Date: December 23, 2019

**ADDENDUM NO. 2**
To Project Bidding Documents for:

**A#03-119686**
**New Student Services Building**
**Compton Community College District**

tBP Project. No. 20987.00

2ND FLOOR PLAN

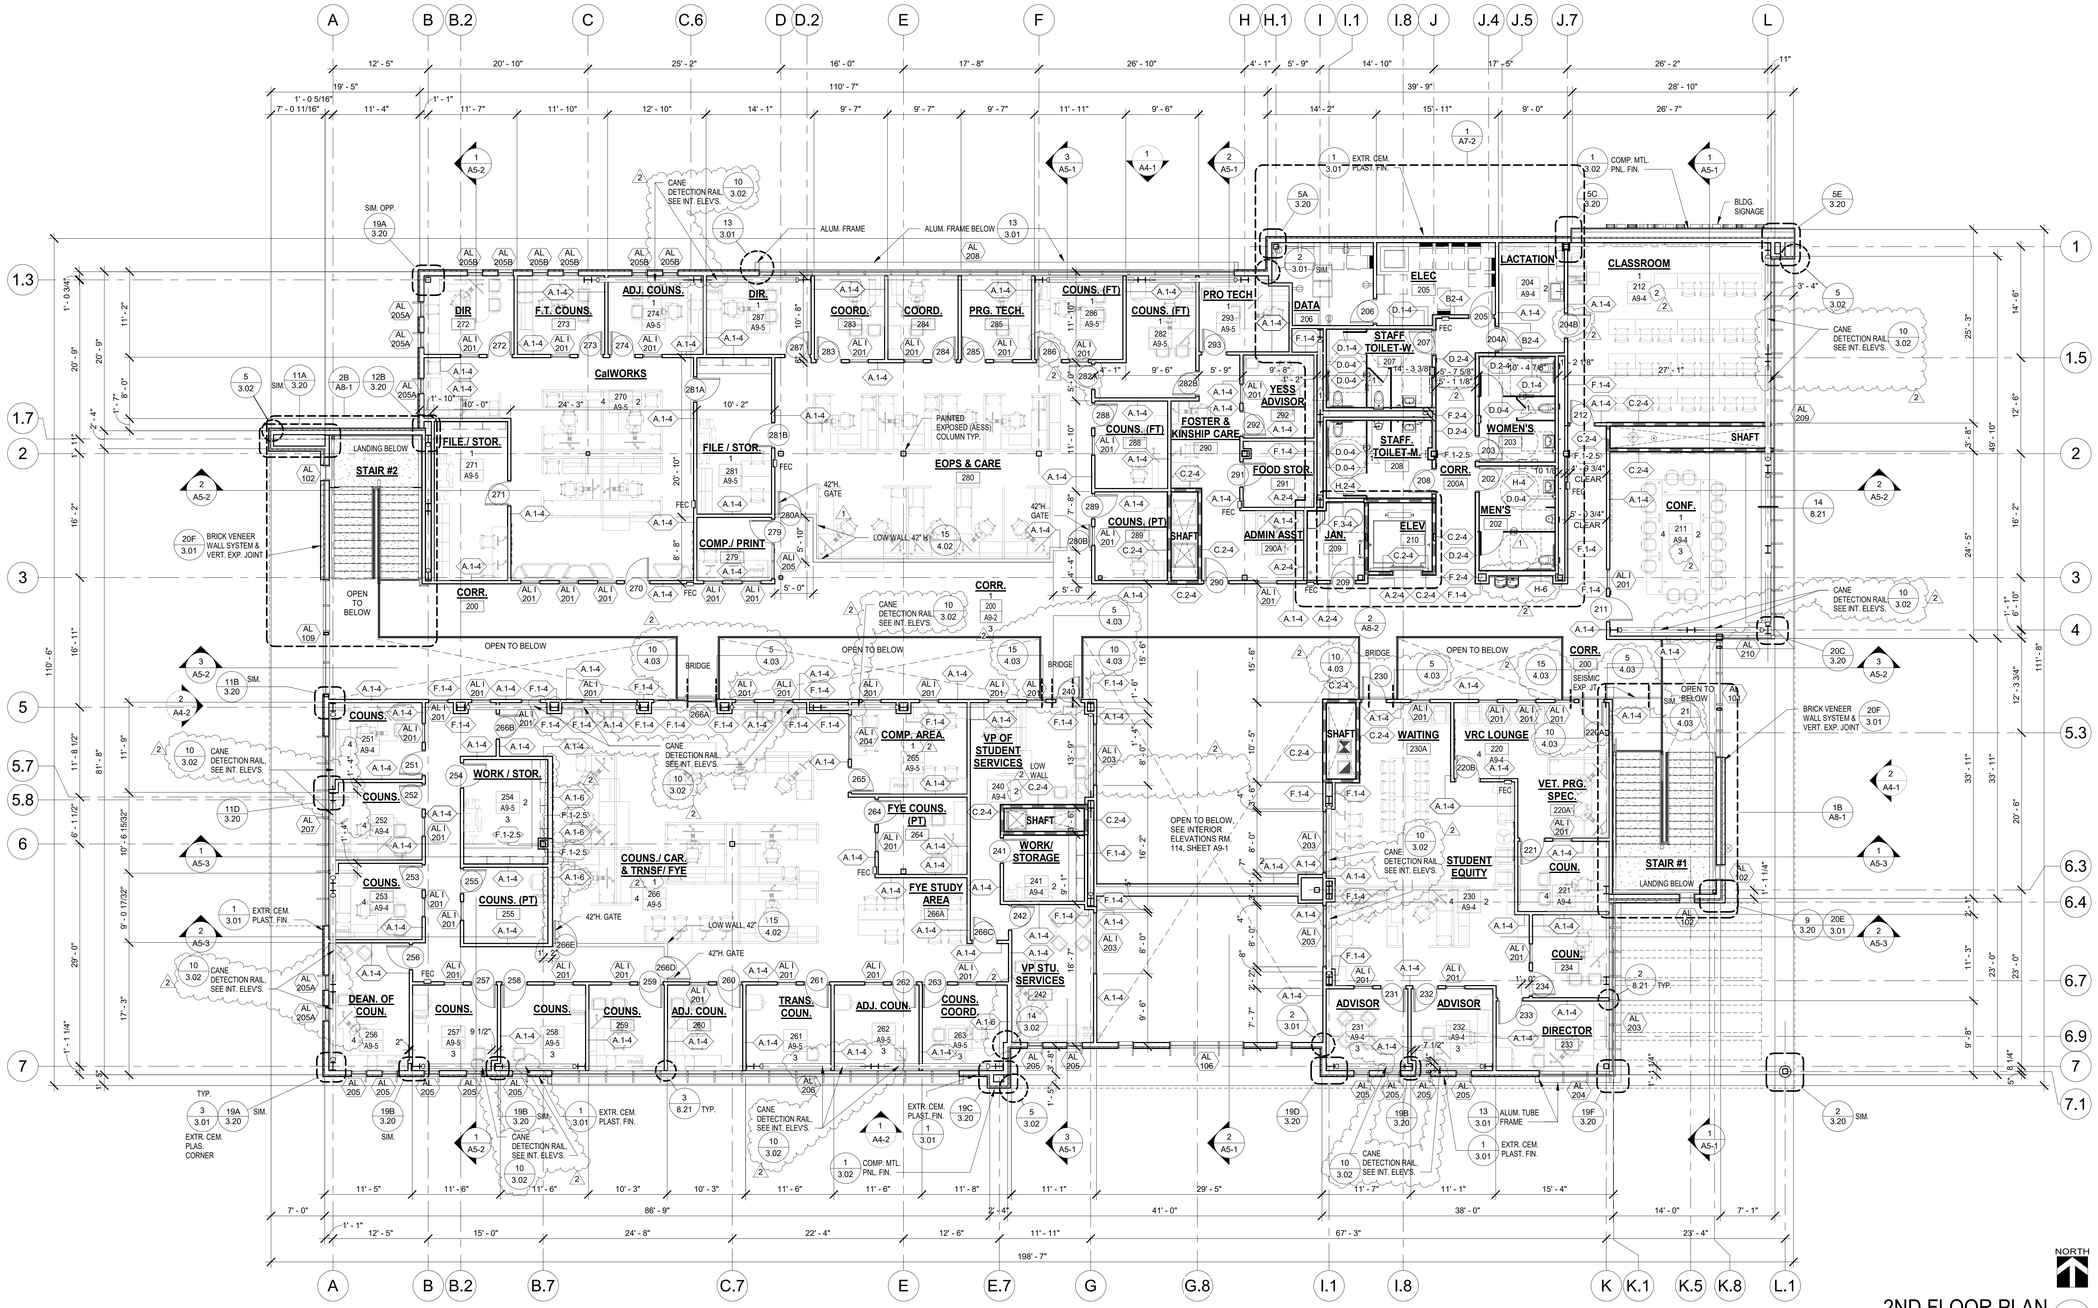
a. Make Couns. Coord. 263 East wall instead of a 4" wall..
   b. Make Couns (PT) 255 and Work/Stor. 254 East wall a 6" wall instead of a 4" wall.
   c. Lactation 204: reverse door swing and flip door #204B.
   d. Couns. (FT) 882: Door #282 revise partion/ door location, flip door, and reverse door swing..
   e. Couns. (FT) 286: Flip Door #286 location.
   f. Added cane detection railing at the following rooms: 211, 212, 230, 231, 232, 240, 251, 252, 256, 257, 258, 261, 262, 265, 266, 274, 278. Added interior elevation references for Cane detection as necessary.
   g. Revised wall stud width to 6-inch studs at Corridor 200.
   h. Added Seismic Expansion Joint Covers at Corridor 200. Added references accordingly.
   i. Revised wall stud width to 6-inch studs at East wall of Rooms 254 and 255.

1ST FLOOR RCP
SCALE 1/8" = 1'-0"
1
NORTH
0' 2' 4' 8' 16'

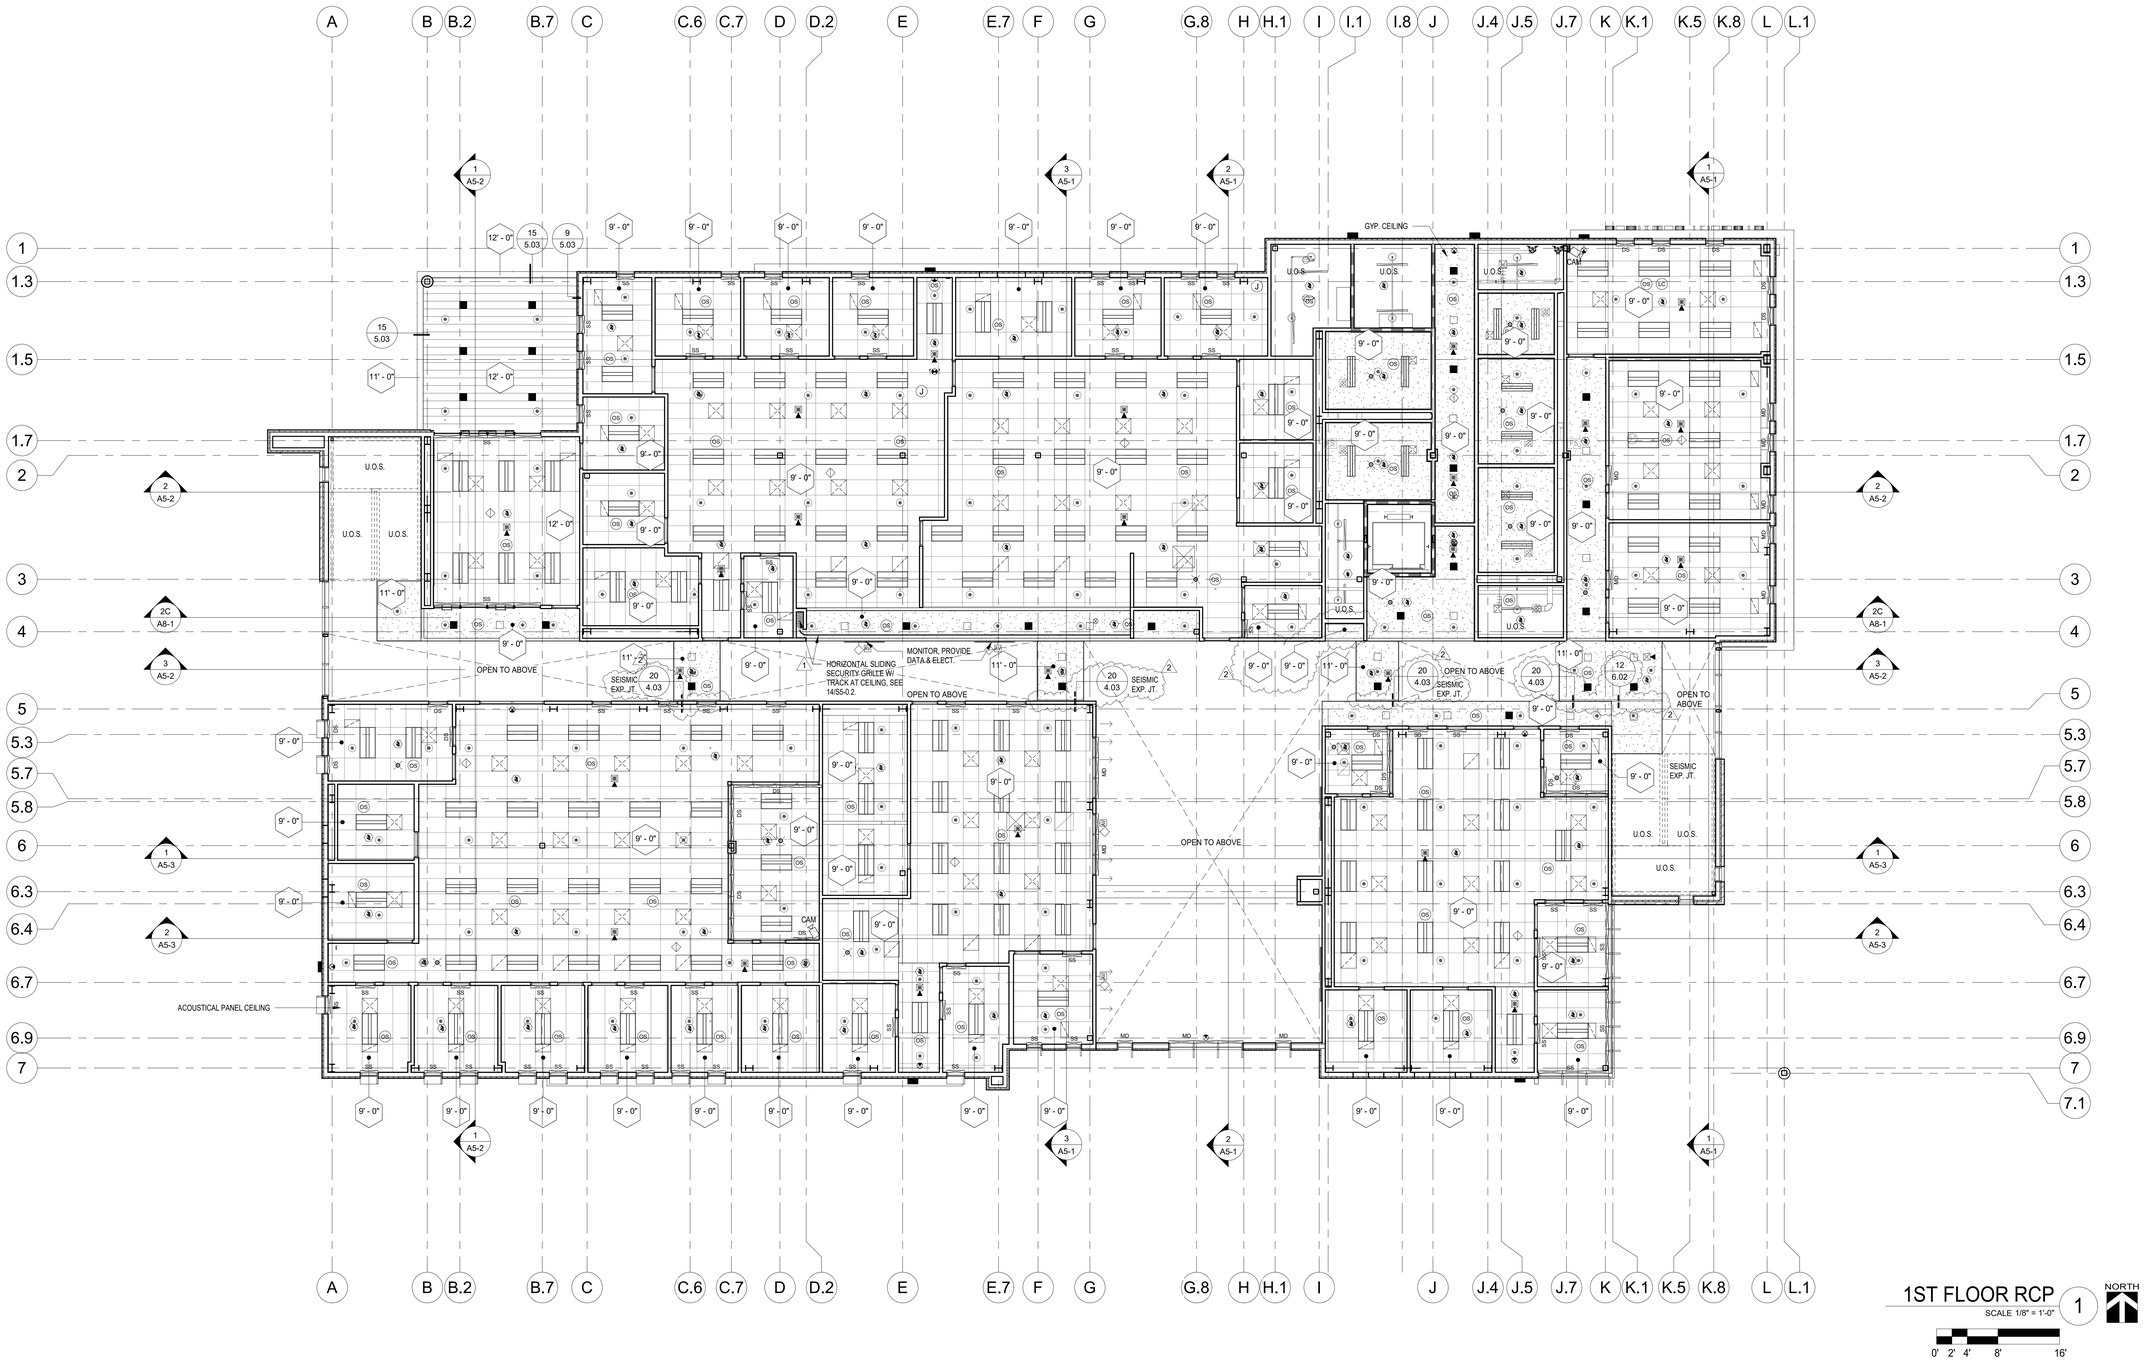
a. Couns. (FT) 282 Revise ceiling per revised partition location.
   b. Clarified soffit height at Drinking fountain in Corridor 200.
   c. Added Seismic Expansion Joint covers at Corridor 200. Added references accordingly.

2ND FLOOR RCP 1 NORTH

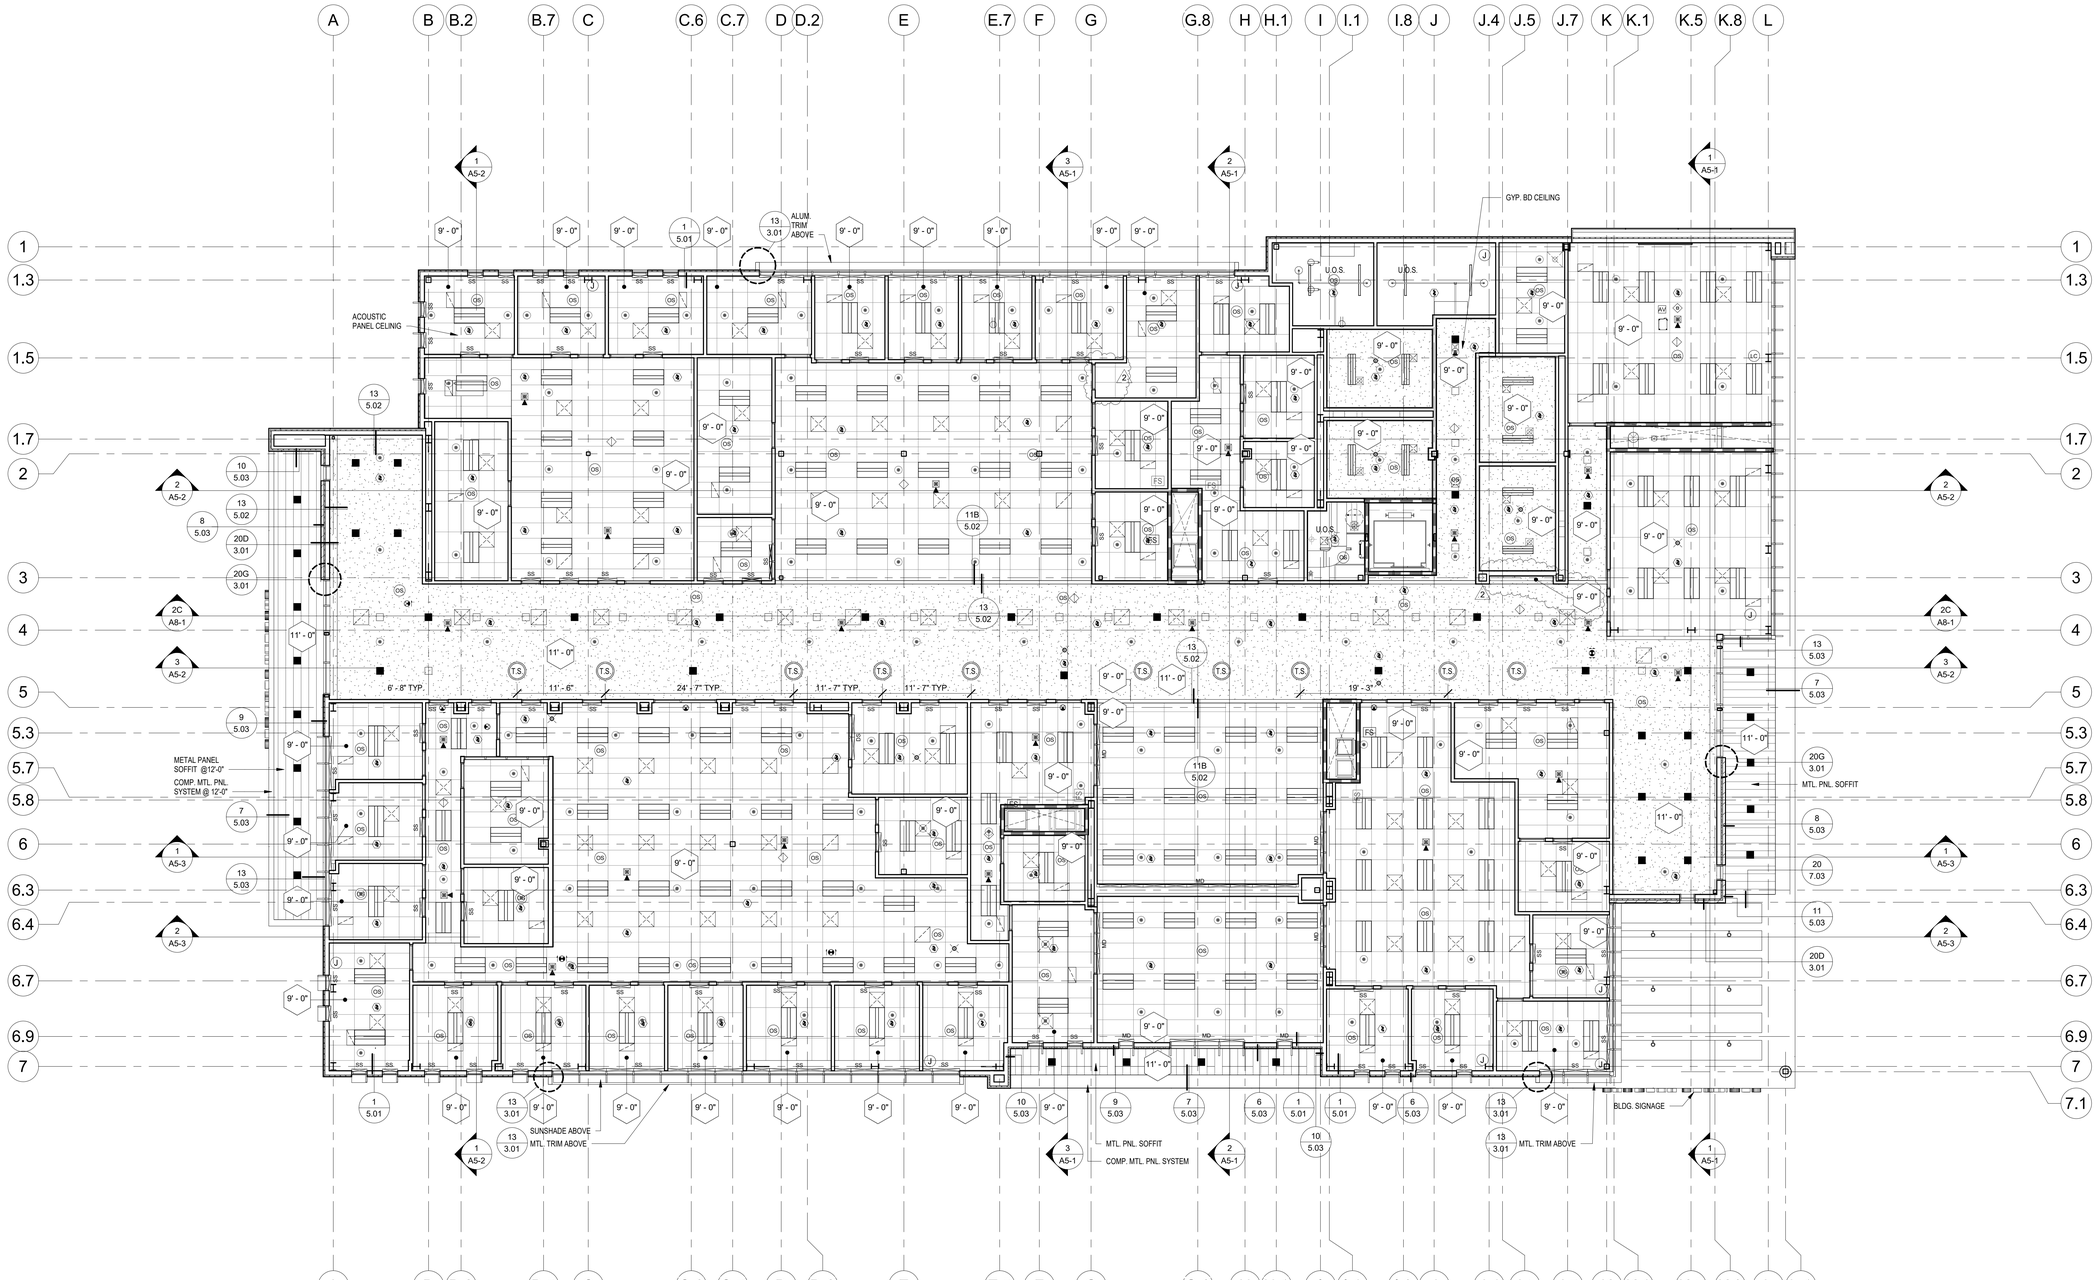
a. Couns. (FT) 282 Revise ceiling per revised partition location.
   b. Clarified soffit over drinking fountain in Corridor 200.

## BUILDING SECTION 3

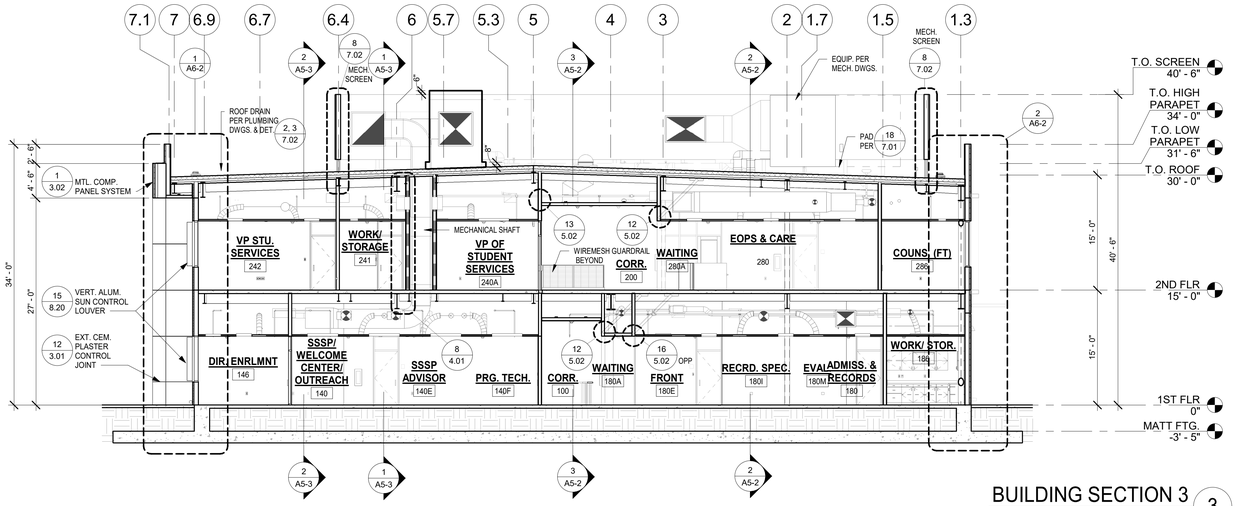
a. Added Seismic Expansion Joint Covers at Corridor 100/Corridor 200.
